REFERENCE
LHC-LBH-EC-0001

Date: 2019-02-01

ENGINEERING CHANGE REQUEST

Installation of the 11 T Dipole Full Assembly in LHC P7 (HL-LHC WP11)

Figure 4 - Section of HL-LHC layout for P7 left (from LHCLSSH_0013, top) and P7 right (from LHCLSSH_0014, bottom)- New components

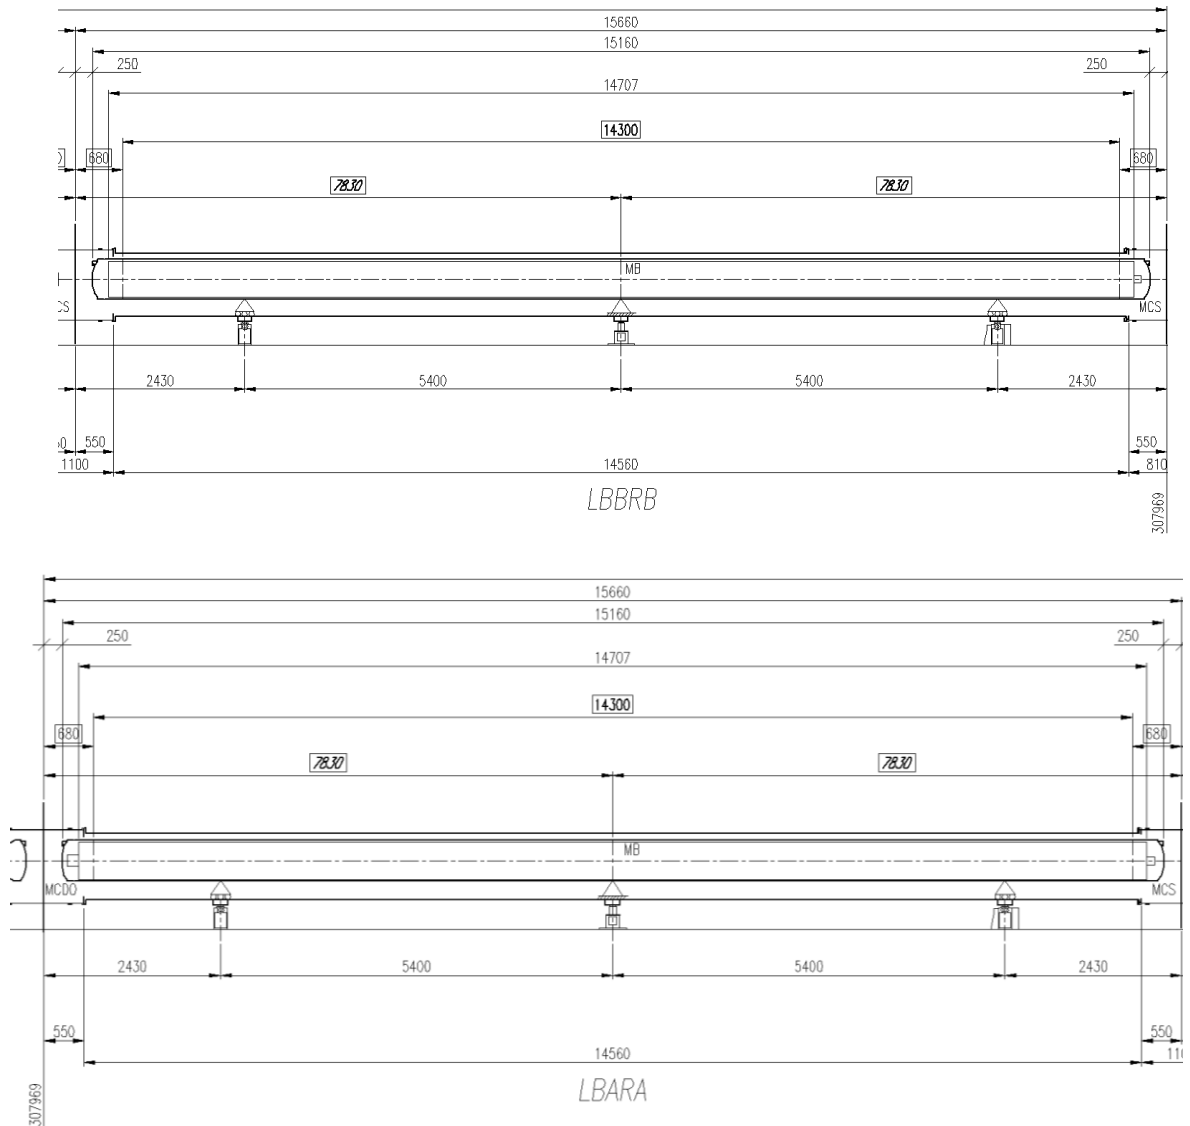
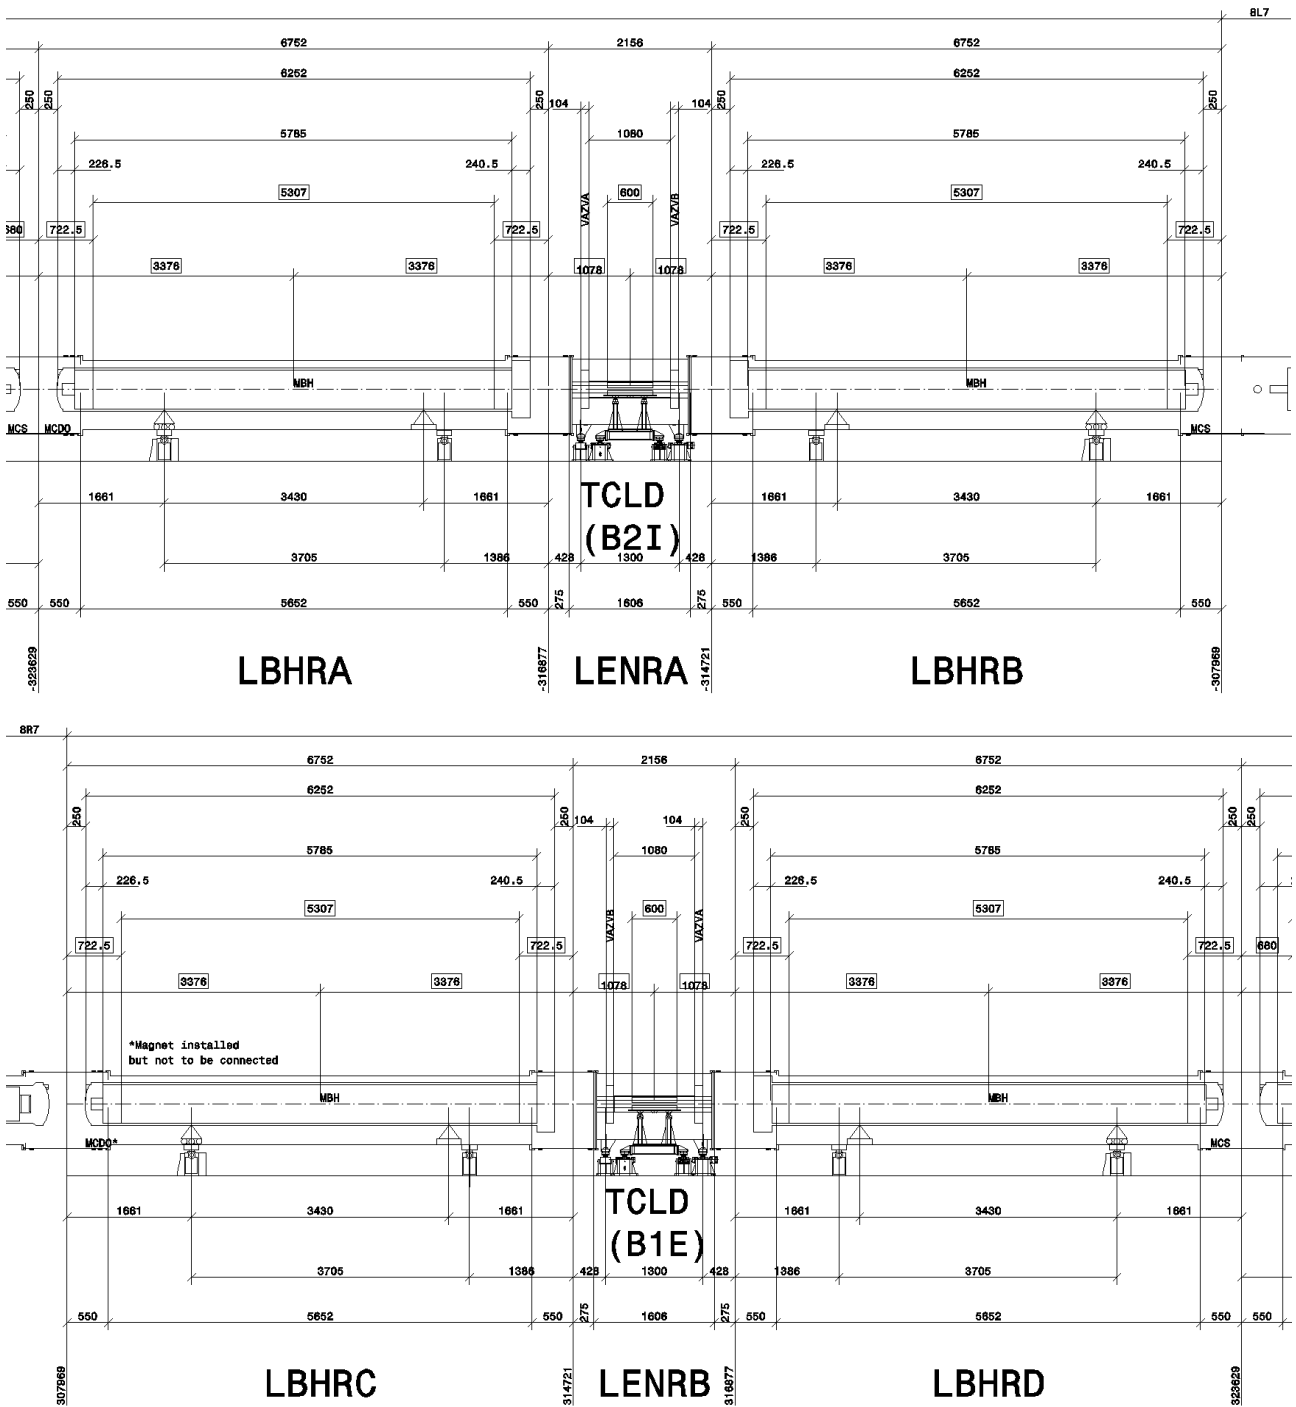
Layout drawings LHCLSS__0029/LHCLSS__0030 (LHC layout for the DS region at point 7) show the present situation in LHC. LHCLSSH_0013/LHCLSSH_0014 (HL-LHC layout for the same zones) show the situation after the installation of the TCLD

collimator and the two short 11 T dipoles and replace the before mentioned drawings after LS2. Figures 3 and 4 show the section of the LHC layout for P7 left before and after the change. Detailed layouts are presented in [13].

Figure 3 - Section of LHC layout for P7 left (from LHCLSS__0029, top) and P7 right (from LHCLSS__0030, bottom) – Replaced magnet.

Figure 5 – Instrumentation for the 11 T dipole, P7 right side [28].

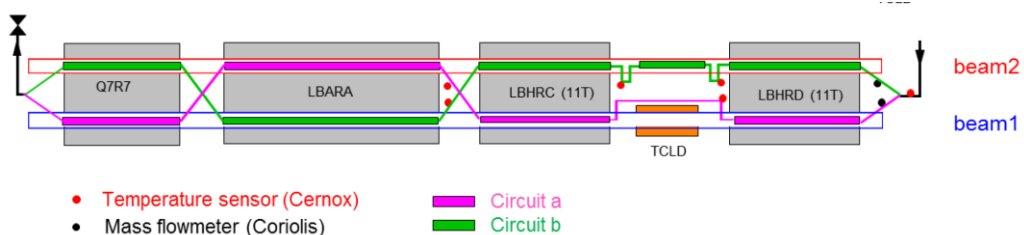
Additional cryogenic instrumentation will be implemented during LS2. A total of seven temperatures sensors (CERNOX) and two flowmeters (Coriolis) will be installed at P7 right side after having installed the 11 T dipole [28]. No additional instrumentation at P7 left side will be installed. This choice was taken because the beam screen heat load on the right side is larger. Figure 5 shows the instrumentation in this half-cell.

Figure 5 - Main dipole circuit RB.A67 configuration for the HL-LHC with the 11 T trim power converter.

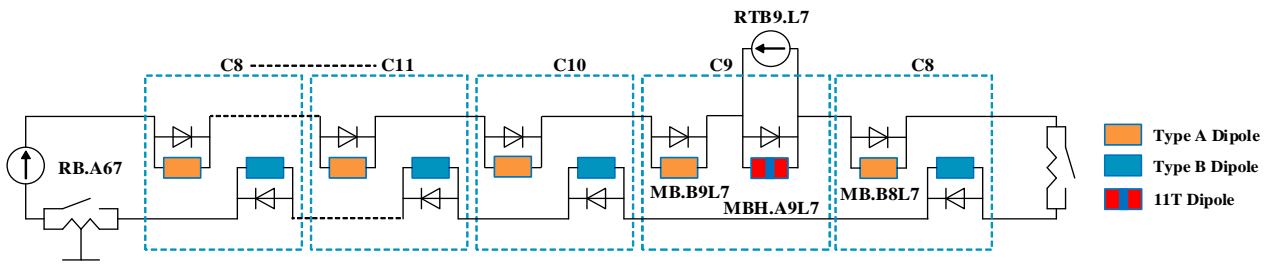
The modified circuit layout of RB.A67 (with trim circuit **RTB9.L7**) and RB.A78 (with trim circuit **RTB9.R7**) is shown in Figures 5 and 6. A detailed description of the circuits is provided in [29, 30], Section 2.1-2.7. The RB circuit characteristics before and after the change are summarized in Table 12. For the circuit RB.A78 the 11 T dipole full assembly

will be placed after the second energy extraction system, creating a little dissymmetry in the RB circuit.

Figure 7 - Location of the new DYPB for the 11 T dipoles.

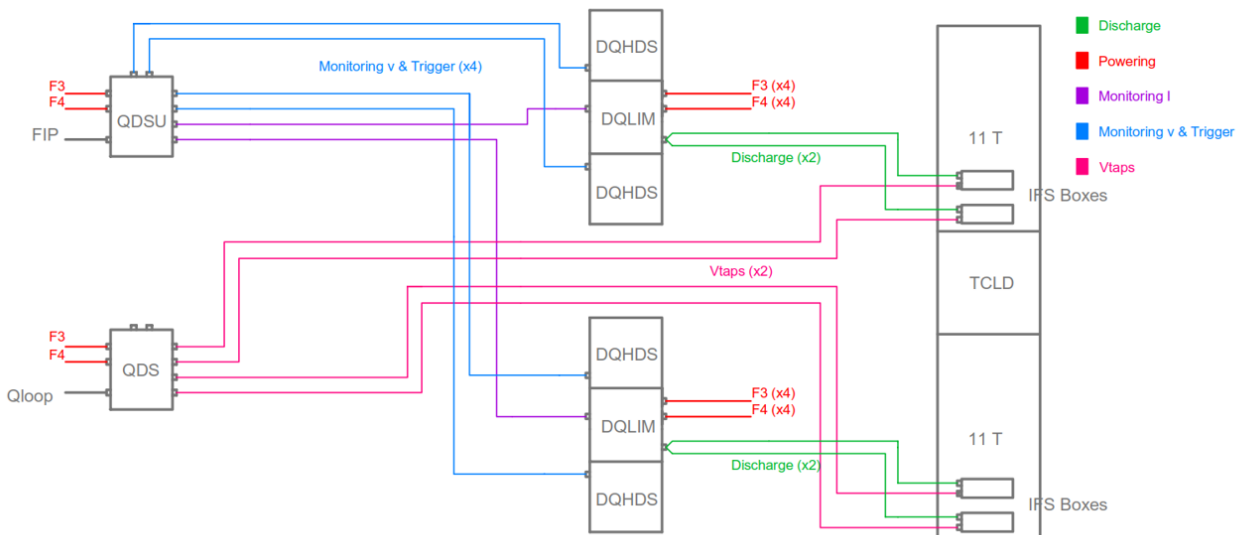
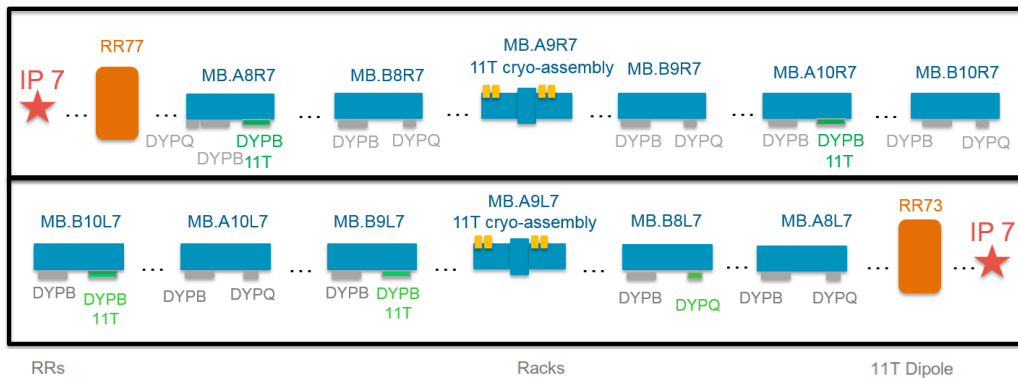
The non-standard QPS racks will be placed at (see the grey boxes in Figure 7):

- L7: 1 rack under MB.B10L7 + 1 rack under MB.B9L7;
- R7: 1 rack under MB.A10R7 + 1 rack under MB.A8R7.

Moreover, there is today a DYPQ rack located under MB.A9L7 that will be moved under MB.B8L7. This requires consequently new cabling between the quadrupole cryostat and the new position of the rack (see Figure 7).
